The Planning Board will be reviewing the Fore River Place PRUD again at a workshop on September 10. At their last workshop, the Board requested the following:

DeLuca-Hoffman Associates, Inc. has completed a review of revised submission materials for the proposed "Fore River Place" subdivision. These materials include the following:

Based on our initial review of the Stormwater Management, Erosion Control and Utility Plans, DeLuca-Hoffman Associates, Inc. provides the following comments and concerns for presentation to the Project Developer:

3.) Gazebo/ Drainage Structure Details.

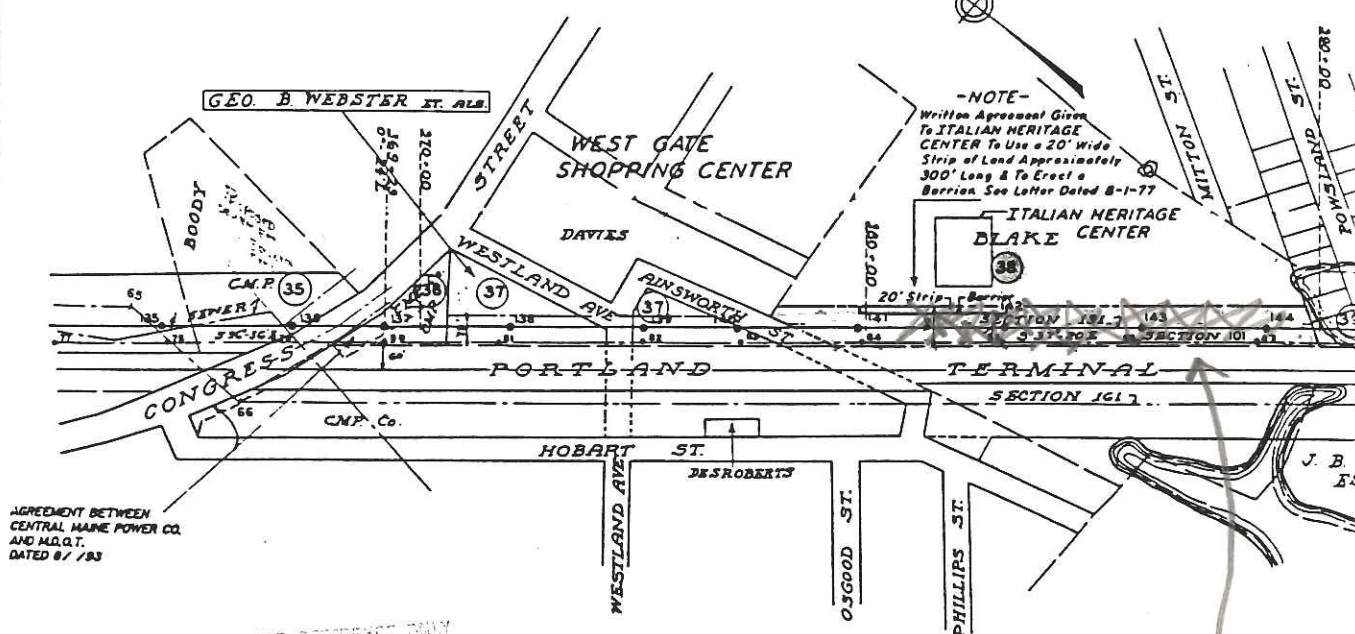
Since there are some uncertainties, with regards to the construction of the drainage structure under the Gazebo, a written report and as-built detail shall be provided upon project completion for City of Portland records.

The hatch to be installed on the deck of the Gazebo needs to be submitted and reviewed to assure that the structural integrity of the Gazebo is maintained, that safety and security is maintained, and that if access is needed, a tripod or mechanism can be installed to allow safe entry into the drainage structure.

3. Joint Swales

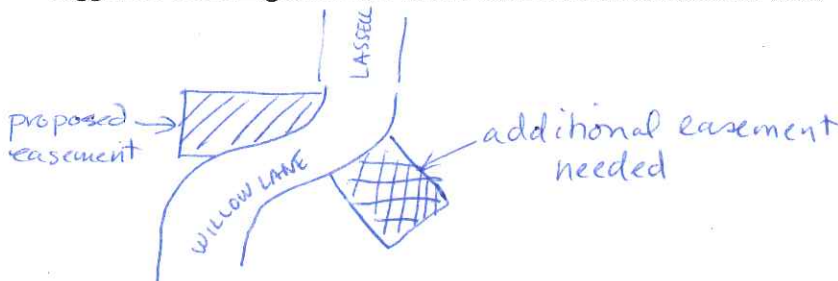
Reviewing staff has asked for a joint swale detail (instead of drainage maintenance easement) for areas between the lots showing width, surface treatment, and design slopes.
